#### **ZONING AMENDMENT STAFF REPORT** Date: December 6, 2007

**NAME** Rollie Steele

**LOCATION** East side of East Drive, 240' + North of Eastridge Place.

**PROPOSED ZONING** R-2, Two-Family Residential District.

## SITE PLAN

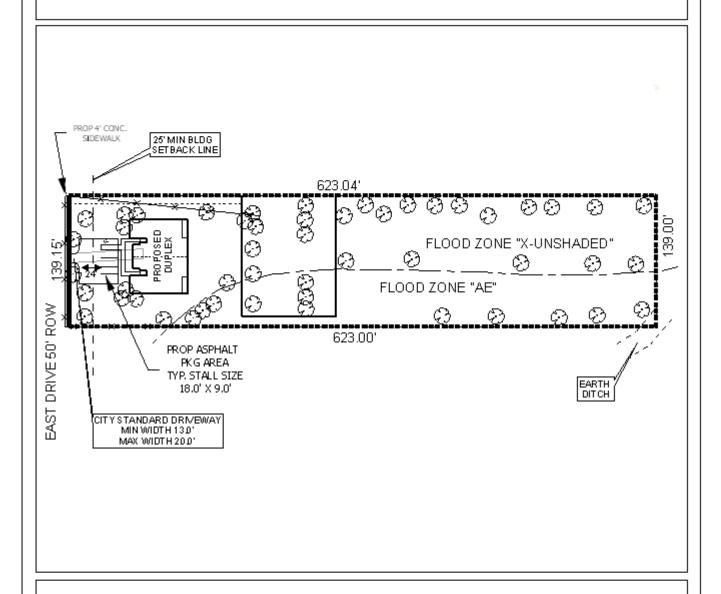
COMMENTS Show minimum finished floor elevation on Lot 22. It is the responsibility of the applicant to look up the site in the City of Mobile (COM) GIS system and verify if NWI wetlands are depicted on the site. If the COM GIS shows wetlands on the site, it is the responsibility of the applicant to confirm or deny the existence of wetlands on-site. If wetlands are present, they should be depicted on plans and/or plat, and no work/disturbance can be performed without a permit from the Corps of Engineers. Must comply with all storm water and flood control ordinances. Any work performed in the right of way will require a right of way permit.

<u>COMMENTS</u> Driveway number, size, location, and design to be approved by Traffic Engineering and conform to AASHTO standards. The minimum driveway width for residential property is thirteen feet. Changes should be made to accommodate this standard.

As indicated on the site plan provided, sufficient parking and maneuvering area for the proposed duplex would be to the front toward East Drive. However, the existing, substandard driveway is proposed as the site access. A minimum 13'-wide drive is required by Traffic Engineering for residential use. Also, no public sidewalk in the right-of-way was indicated on the site plan, as required for new development. Both an enlarged drive and a public sidewalk should be indicated on future site plans should the rezoning be approved.

only the initially-proposed one duplex unit toward East Drive centered on the site. Inasmuch as this may be an appropriate location for a single duplex unit, no allowance is made for access to any future units. Due to the 139'+ street frontage of the site, only one curb cut to East Drive should be allowed. Therefore, the site plan should be revised to provide a single access to the site which would serve not only the initially-planned duplex unit, but would also allow access to the interior of the site for all future units. Also, any future units would require a Planned Unit Development application and full site compliance. No site compliance would be required for the initial unit, and if this rezoning is approved, site compliance can be postponed until any additional units are built. However, a sidewalk in the public right-of-way would be required.

- 1) the site is limited to one curb cut to East Drive, with the size, location, and design to be coordinated with Traffic Engineering, and conform to AASHTO standards:
- 2) submission and approval of a Planned Unit Development application for any future units beyond the initial duplex unit;
- 3) full compliance with the landscaping and tree planting requirements of the Zoning Ordinance;
- 4) provision of a sidewalk; and
- 5) full compliance with all municipal codes and ordinances.
